Software Version : EasyBuilder8000 V4.65.13

Applied Models:

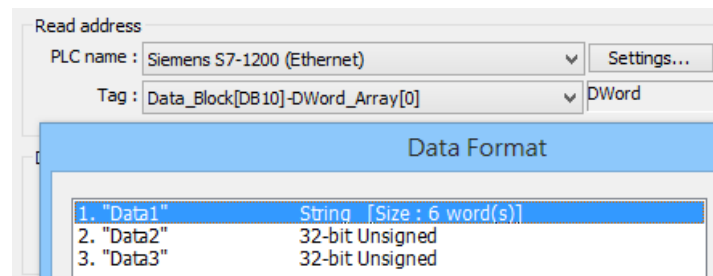
5. Fixed the problem where Event Log management has no effect on new events.
6. Fixed the problem where Macro security control may fail due to the change of user-defined tag names.
7. Fixed the problem where S7-1200 tag information cannot be collected via VPN.
8. Fixed the problem where the tags of Rockwell - Free Tags driver cannot be selected.
9. Fixed the problem where the Macro function, GetError(), may get incorrect error code during execution.
10. Fixed the problem where Word Lamp shows incorrect state when offset is a negative value.
11. Fixed the problem where the data sampling steps following a String data failed when an Array tag was selected as the read address of a Data Sampling object. As shown in the following figure, since "Data 1" is a String, Data Sampling could only record "Data 1" before this release.
